TO: T10 Membership
FROM: Paul A. Suhler, Quantum Corporation
DATE: 21 October 2008
SUBJECT: T10/08-409r0, ADT-2: Internet ADT (iADT)

Figure k – Connection State Diagram

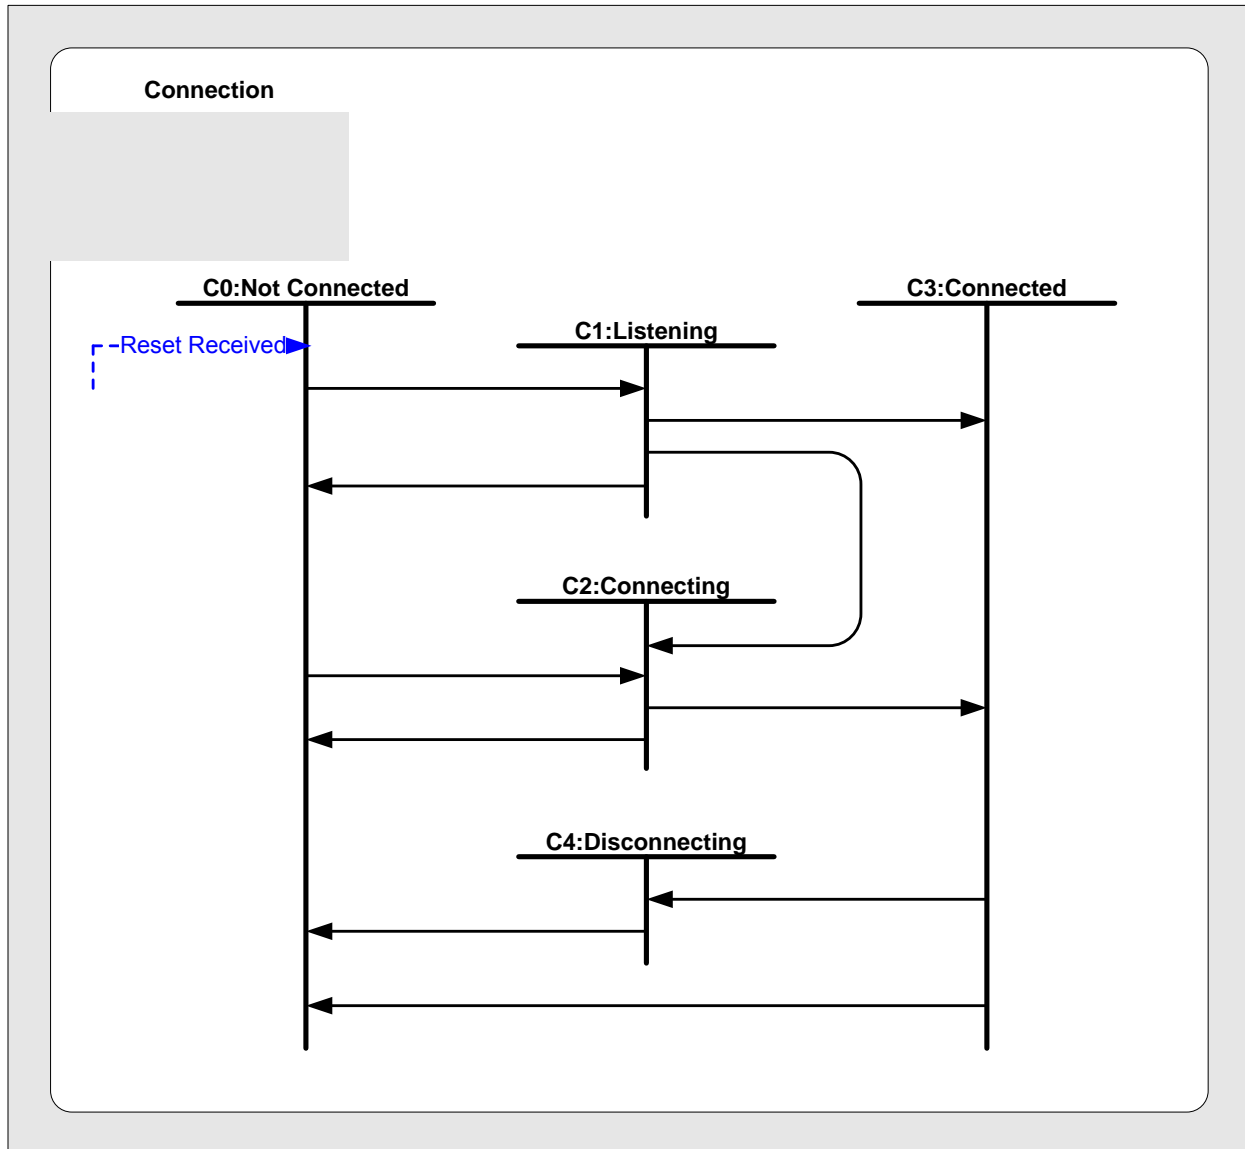
Note: We may want to add service requests as inputs, service indications as outputs, and other inputs.
